## Access Compliance Report Public Rights-of-Way (Curb Ramps)

Intersection ID: 10041631Main Street: WHITEHALL\_PARK\_DRCross Street: N/ALocation:NEADA ID: C80AED1FB0F2Ramp Type: BlendTrans2Initial Pass/Fail: FailOverall Compliance: NoSeverity Score: 12.5

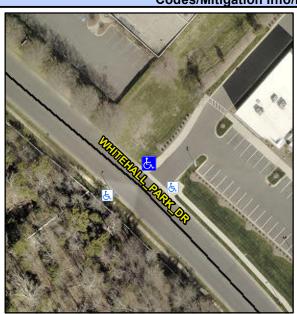
60.0 No

R304.5.3

Remove & Replace Curb Ramp With Two New Directional Ramps or Equivalent.
